# CITY OF ALBUQUERQUE

RE: **4936 Pan American  
Grading and Drainage Plan  
Engineer's Stamp Date 10/11/17  
Hydrology File: F17D032**

Based upon the information provided in your submittal received 10/12/17, the Grading and Drainage Plan cannot be approved for Grading or Building Permit until the following comments are addressed.

|               |                               | SHEET TITLE     | Grading Plan  |

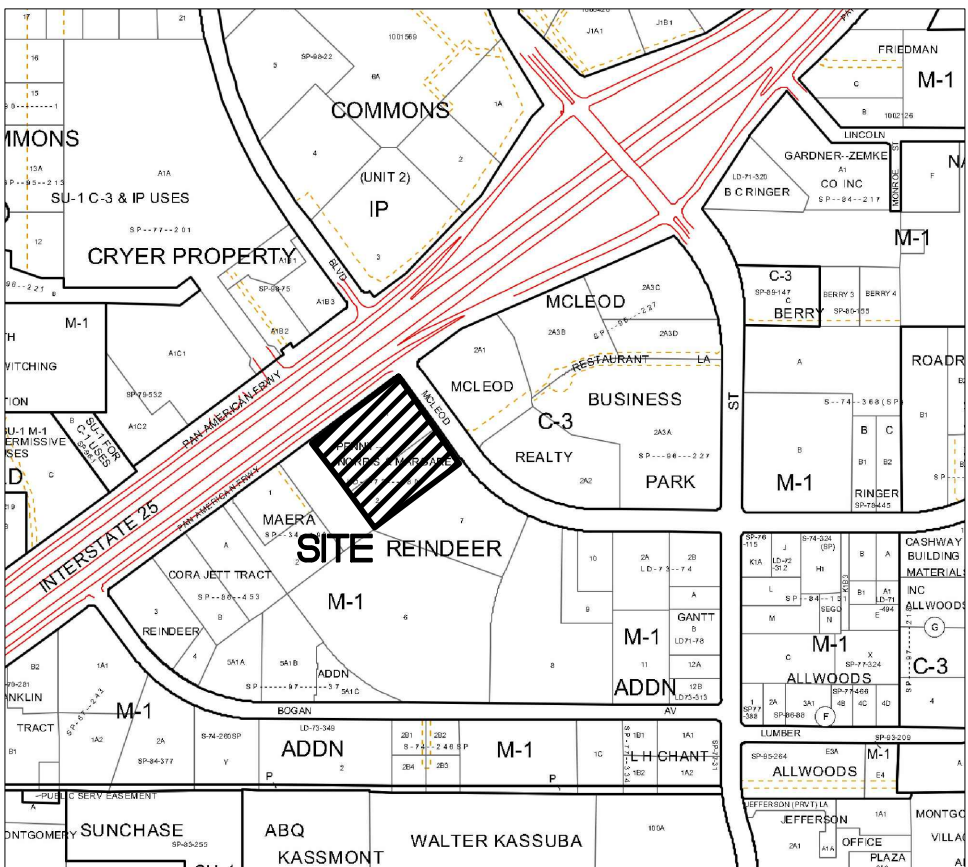
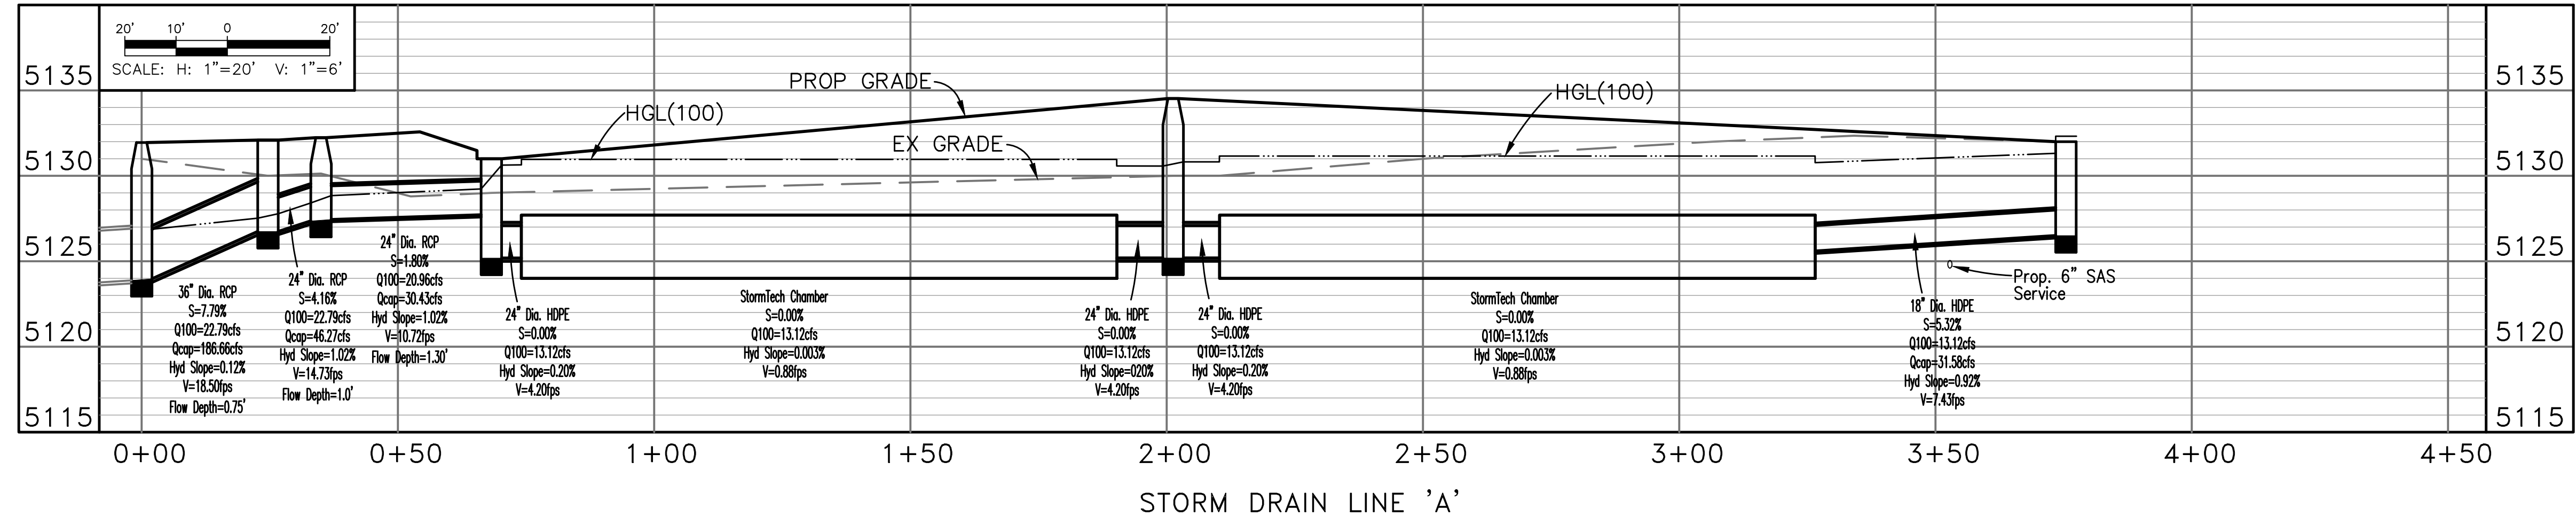
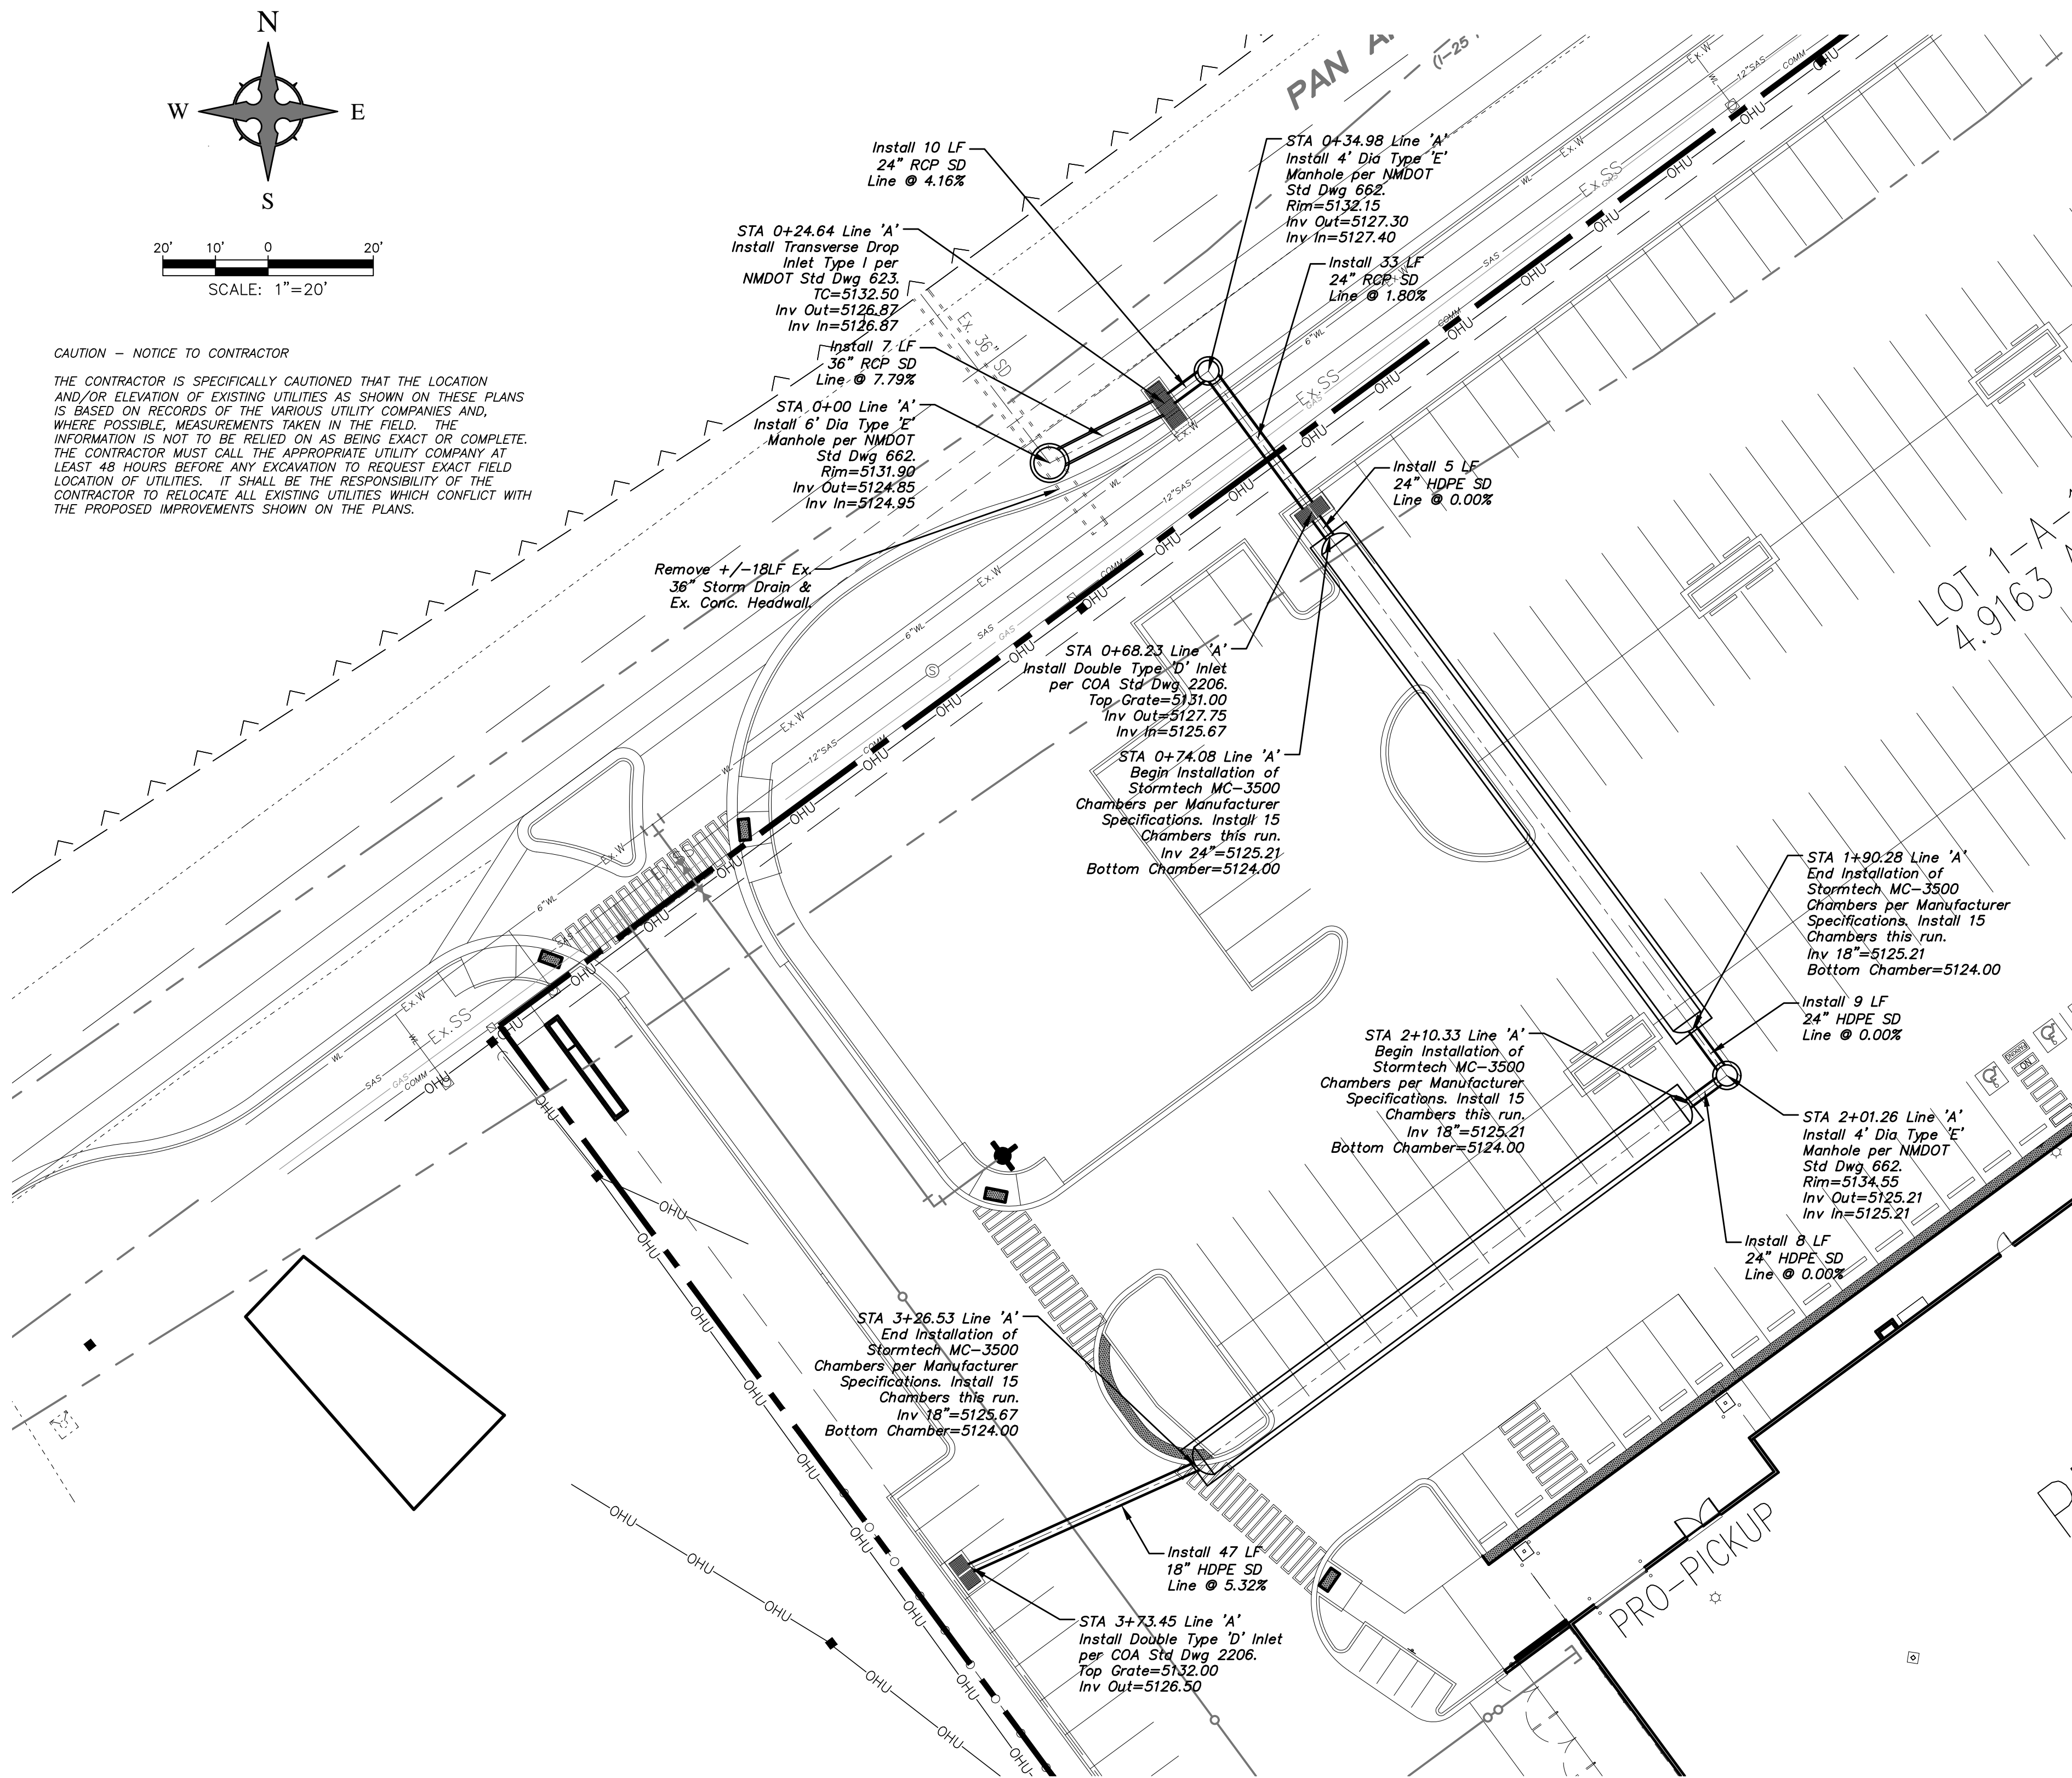
3. How much fill/cut is being placed in the floodplain?
4. No increased runoff to overcapacity systems (floodplain) can be authorized per § 14-5-2-12 (10)(G) of the Albuquerque Code of Ordinances. The current plan demonstrates this, however any changes need to continue to demonstrate this as well.

7. Regarding first flush volume: this site qualifies as redevelopment and is only required to retain runoff from the 80<sup>th</sup> percentile storm ( $\text{Vol.} = 0.26'' * \text{Imp. Area}$ ).
8. It is unclear how Basin C routes entirely to the curb opening. What is the cross-slope on the driveway? Is everything graded towards the curb opening?

SHEET TITLE  
Storm Drain Plan

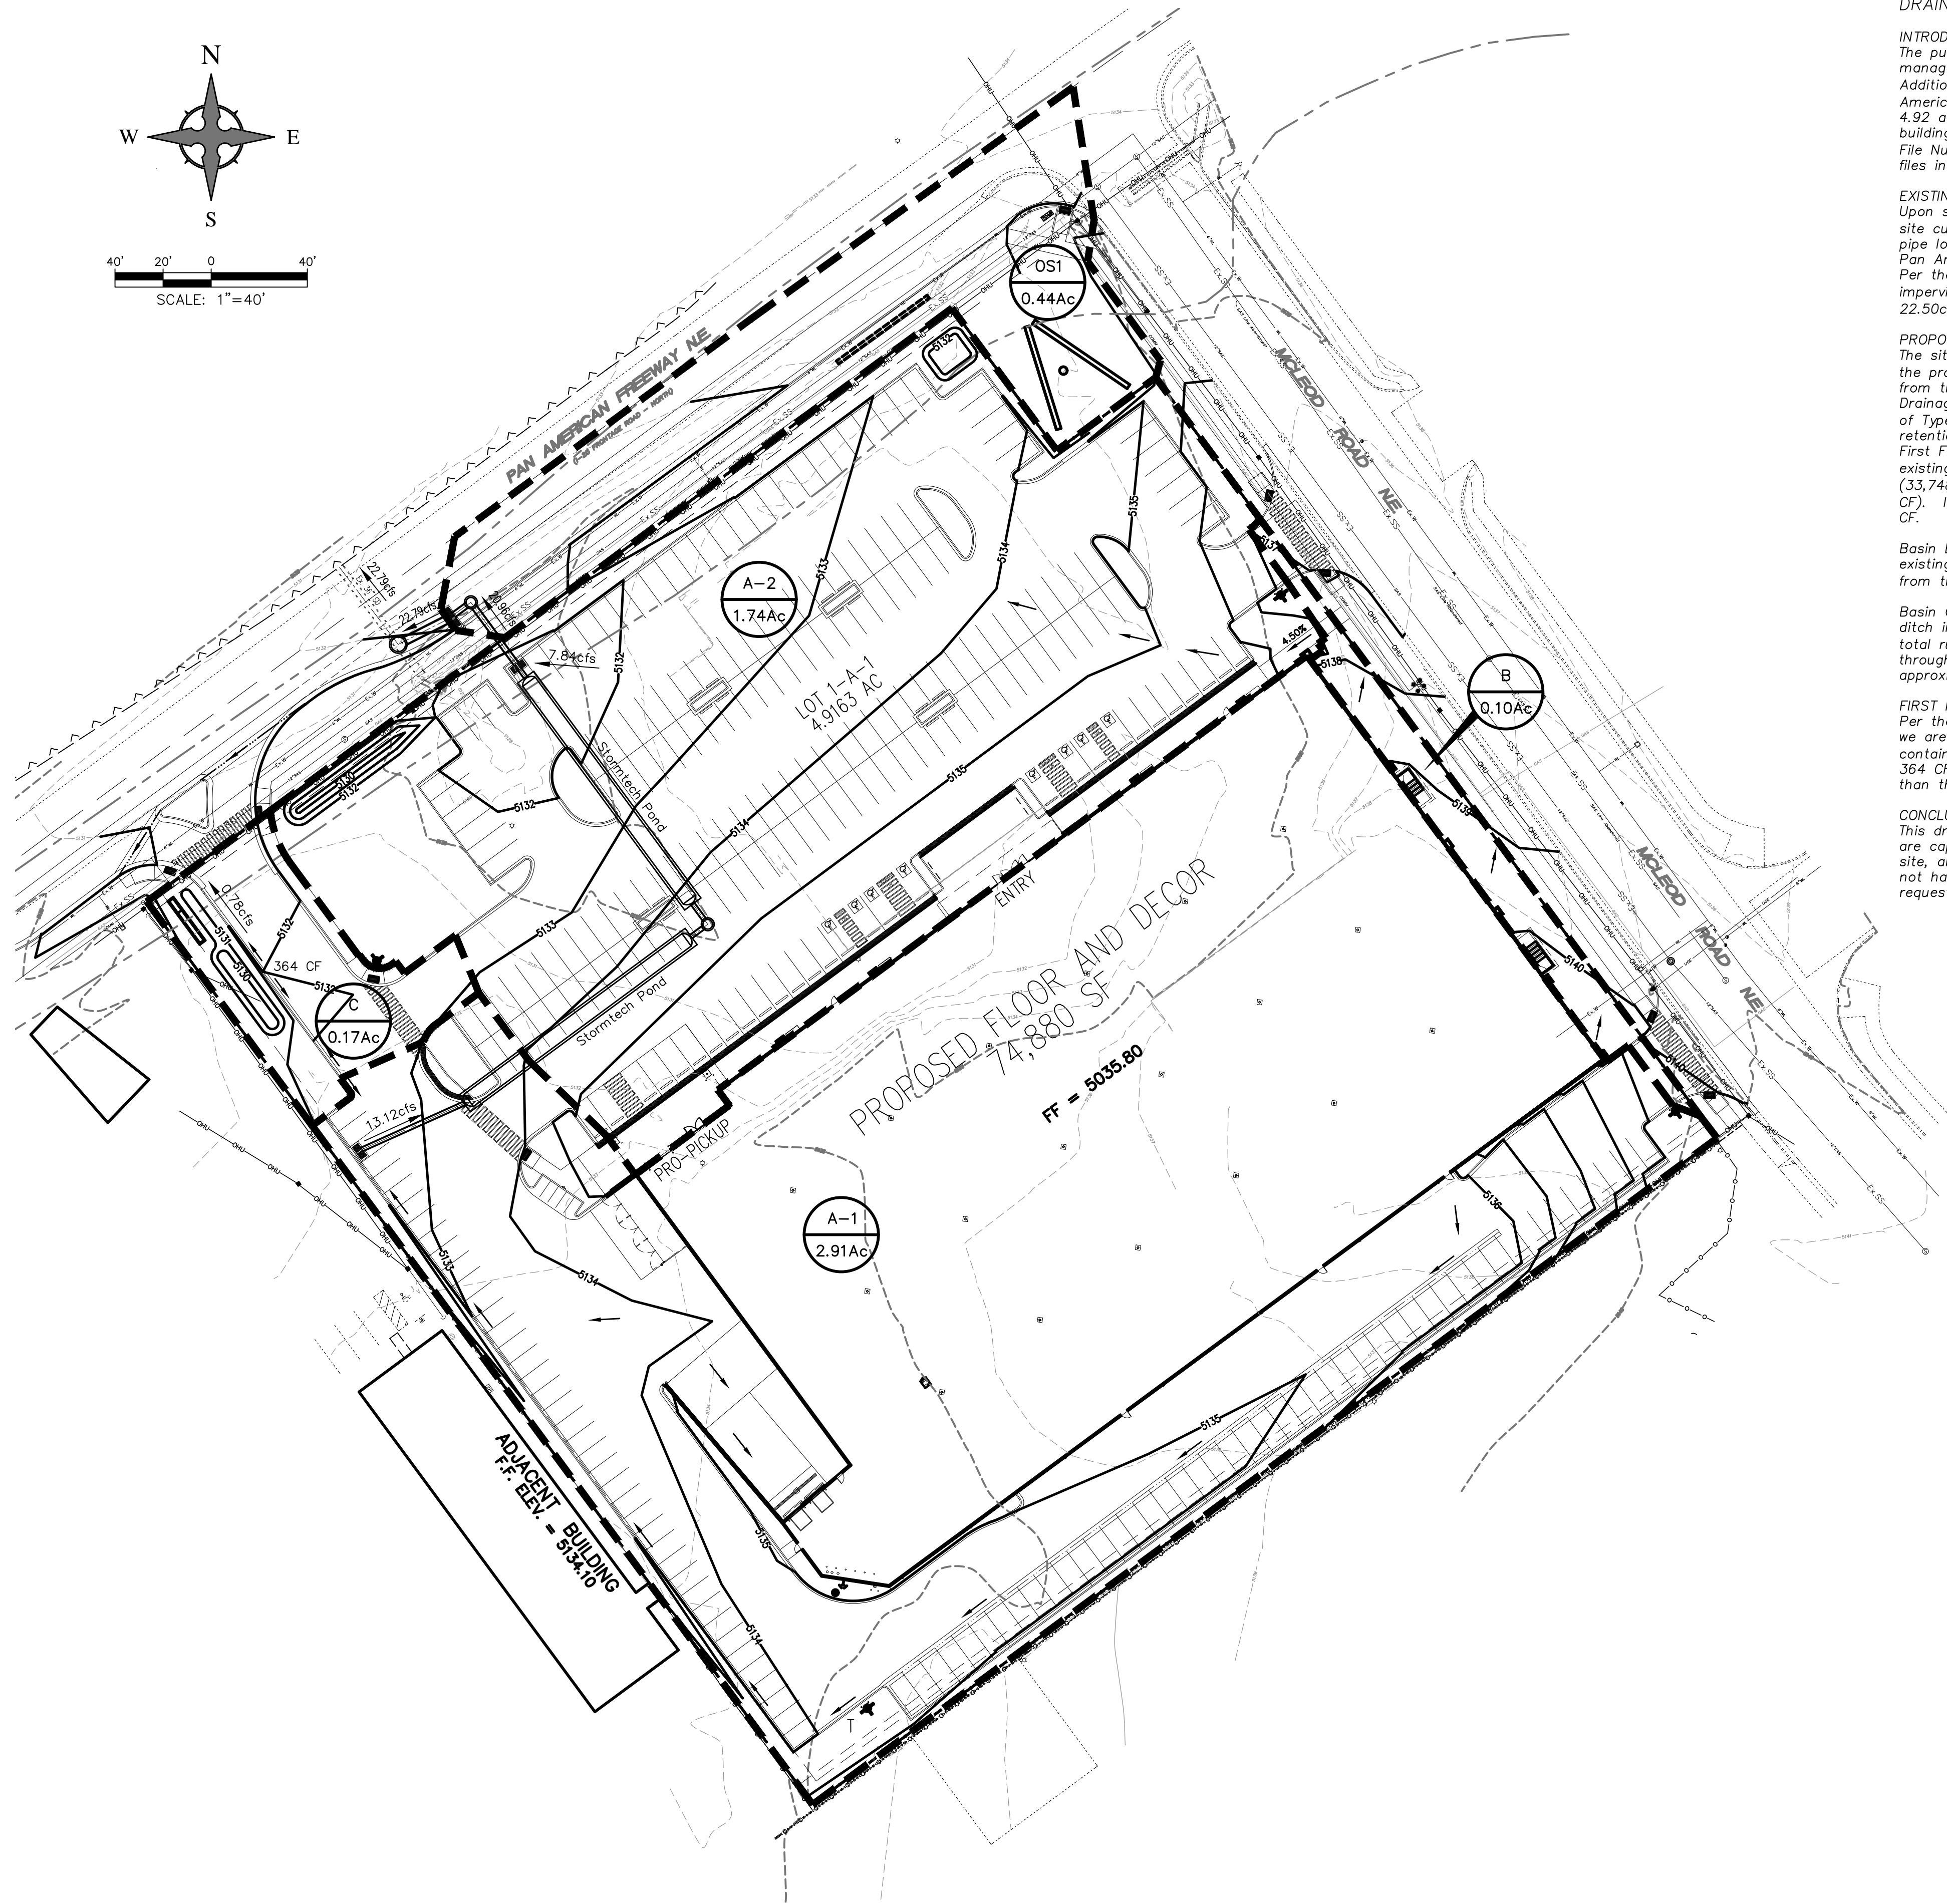
5. Provide volume calculations for the stormtech basins; the City allows only 30% void space for the gravel bedding.
6. Quantify the first flush volume that bypasses first flush facilities. It appears that Basin B and most of Basin C bypass.

9. Payment in Lieu is required for the first flush bypass volume (\$8.00/CF).
10. How does the roof drain? Include clarifying language, flow direction, soffits, gutters, etc...
11. A Private Facility Drainage Covenant is required for the stormwater quality ponds/stormtechs. The original notarized forms, exhibits, and recording fee (\$25, payable to City of Albuquerque) must be turned into DRC (4th, Plaza del Sol) for routing. Please contact Charlotte LaBadie (clabadie@cabq.gov, 924-3996) or Madeline Carruthers (mtafoya@cabq.gov, 924-3997) regarding the routing and recording process for covenants.
12. Water quality inlets are recommended at the inlets to the stormtechs to reduce sedimentation and maintenance in the stormtechs.
